# December 2017 Technical Exchange Action Items and APCS\_NT Sensitivity Study

DOE EPA Technical Exchange on WIPP Recertification

Presented by Brad Day on February 13, 2018

Analysis of two realizations that cross WIPP compliance boundary

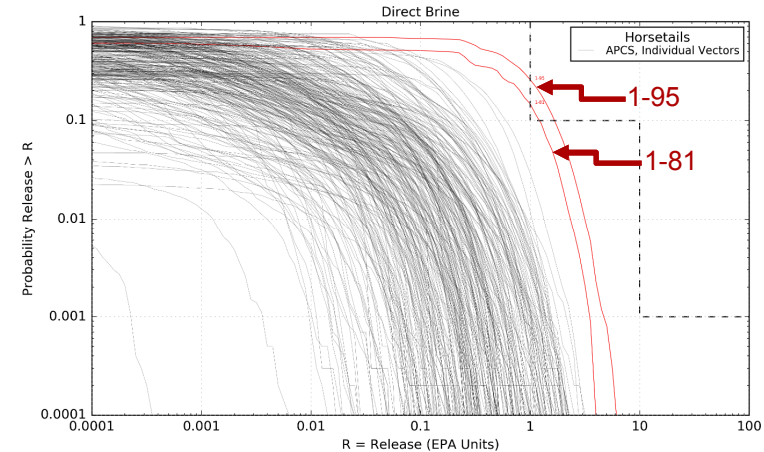
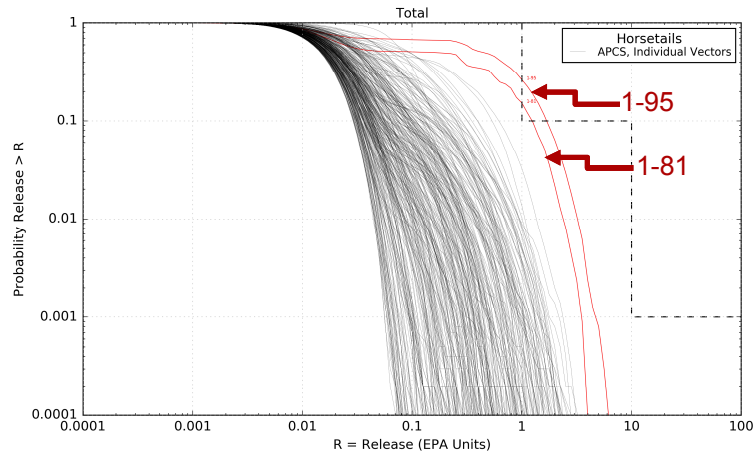
- Realizations are for vectors 81 and 95 of replicate 1
- STEPWISE analysis indicates CASTILER:PRESSURE, GLOBAL:PBRINE, and SOLMOD3:SOLVAR as most important epistemic variables

Analysis of two realizations that cross WIPP compliance boundary

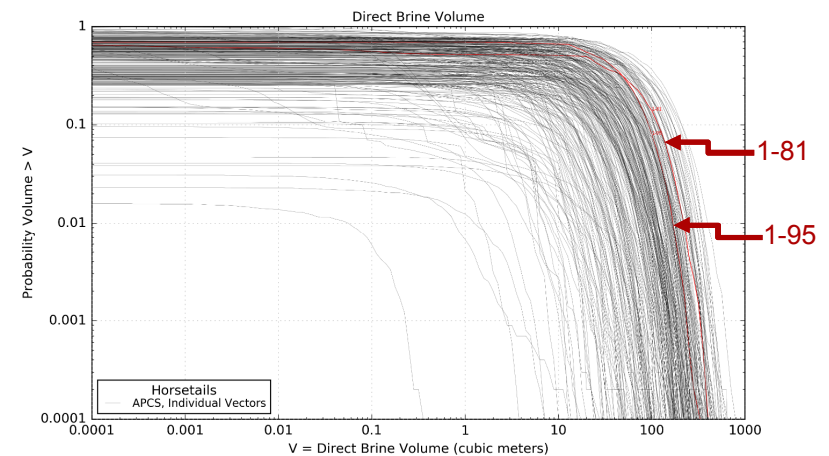
- R1V95 has lower DBR volume than R1V81
- R1V95 has higher solubility uncertainty multiplier than R1V81
- R1V95 has highest release

Analysis of saturation vs pressure in North Rest-of-Repository

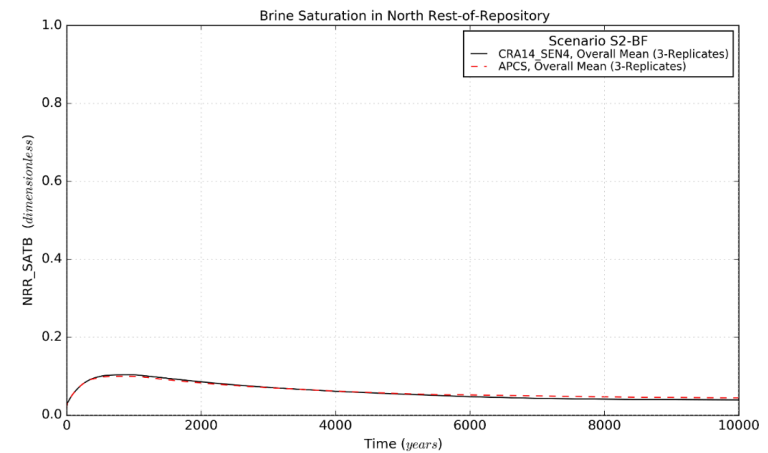
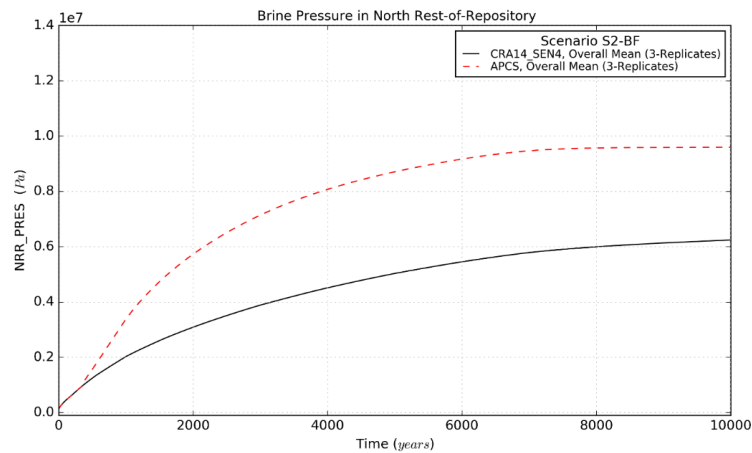
- Why is brine saturation not decreasing under the influence of increased gas flow to the north and an associated increase in brine pressure?
- Answer is due to the effect of gas/brine pressure that results in an increase in porosity due to reversal of creep-closure

Analysis of saturation vs pressure in North Rest-of-Repository

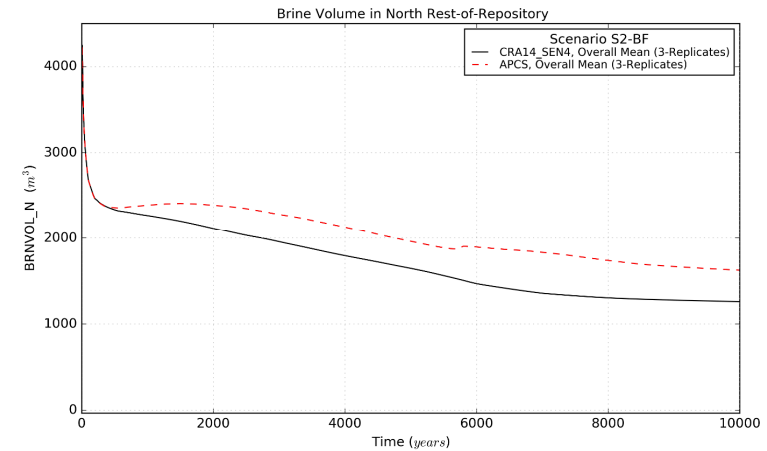
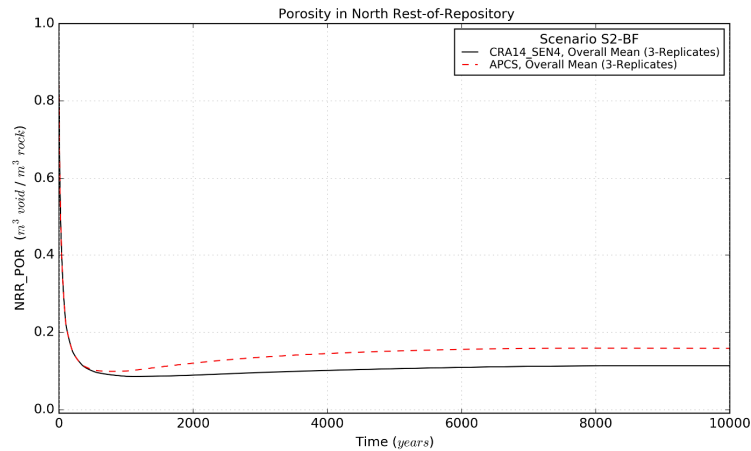
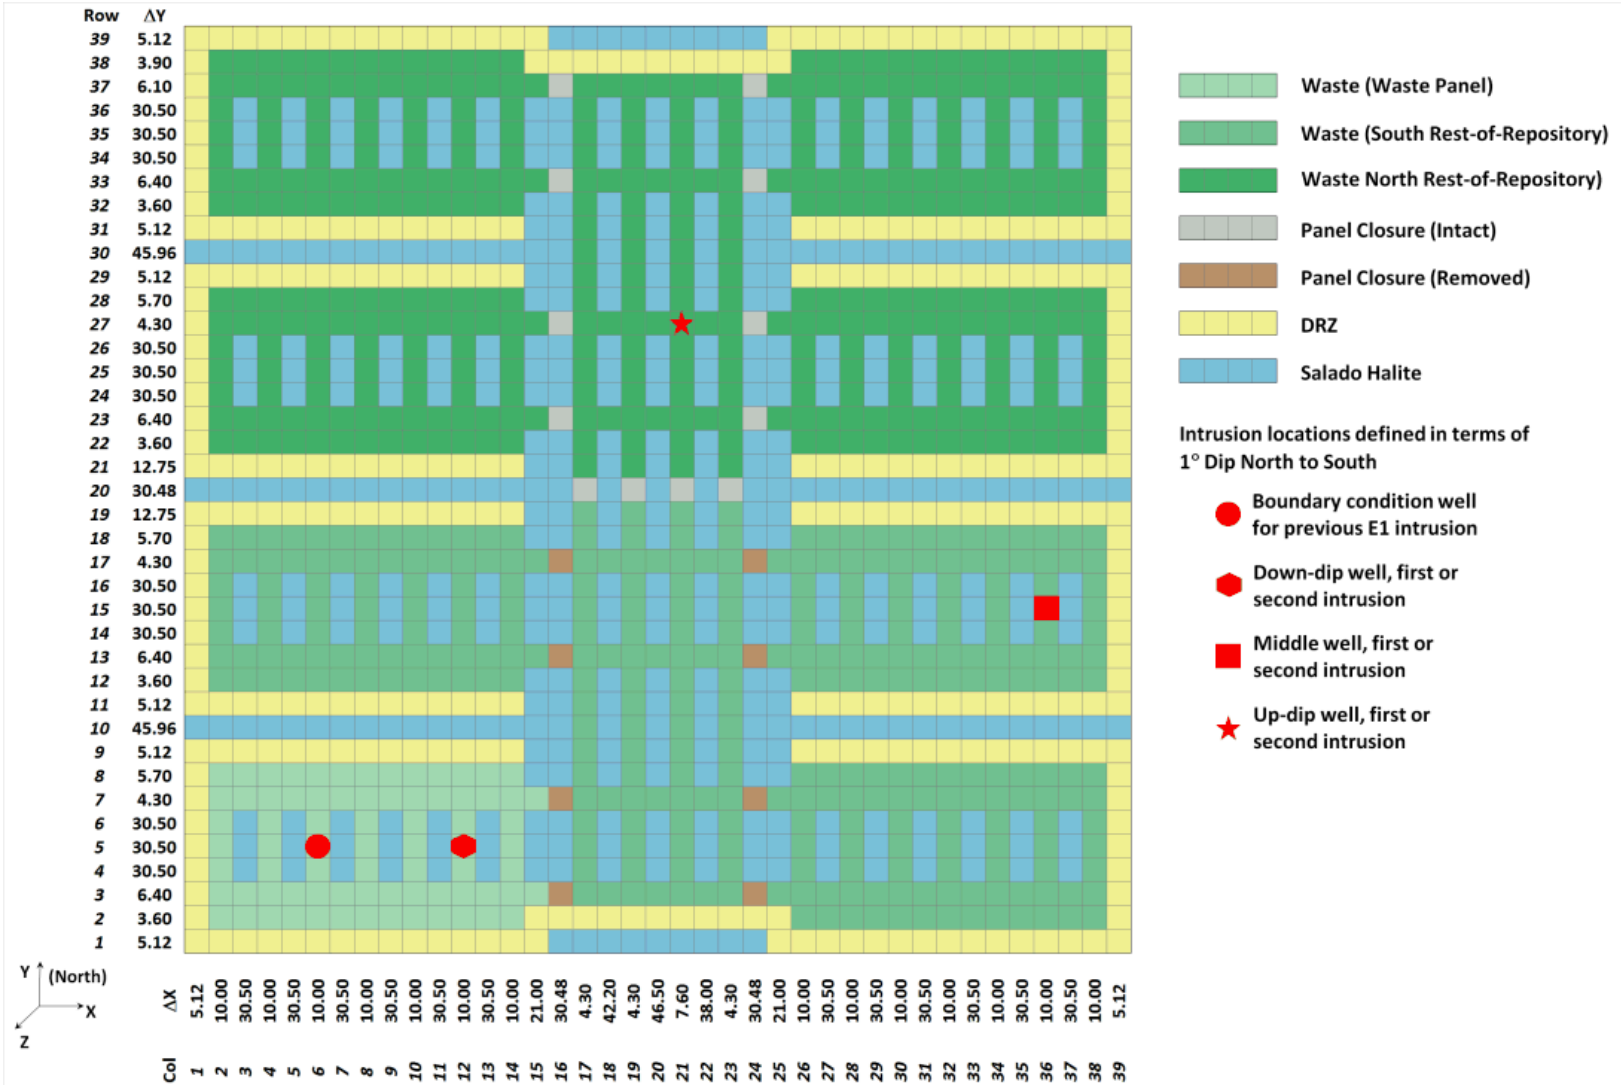
- Gas flow into the NRoR does not necessitate a reduction in brine saturation because there is additional pore space made available by the pressure-induced reversal of creep closure within the NRoR under APCS to accommodate additional brine and gas

Analysis of timing and presence of borehole intrusions for BRAGFLO\_DBR

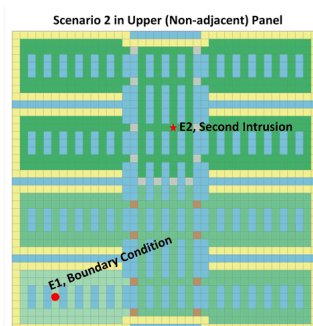
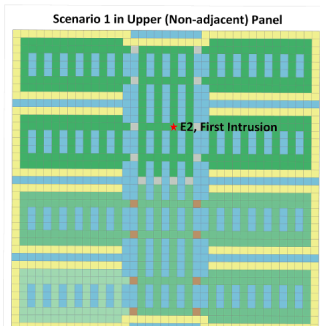
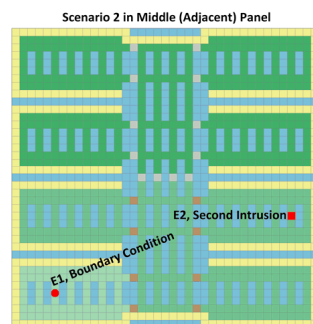
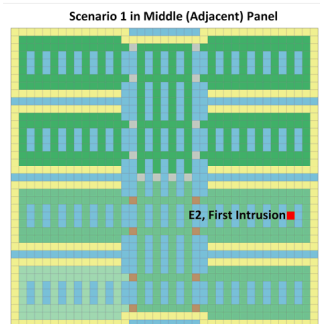
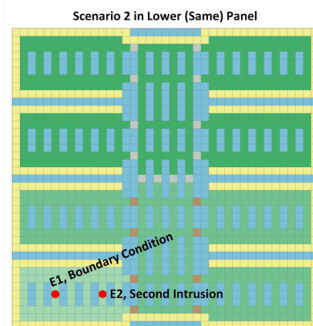
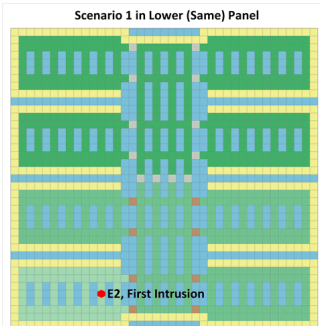
- Initial conditions for the DBR simulation are taken from the corresponding BRAGFLO Salado flow solution at the time of the latest intrusion
- Total number of DBR analyses for a full PA is equal to 26 scenario/time combinations x 3 locations x 300 realizations = 23,400
- Pressure-based boundary condition well simulates continued communication with Castile for Scenarios 2/3
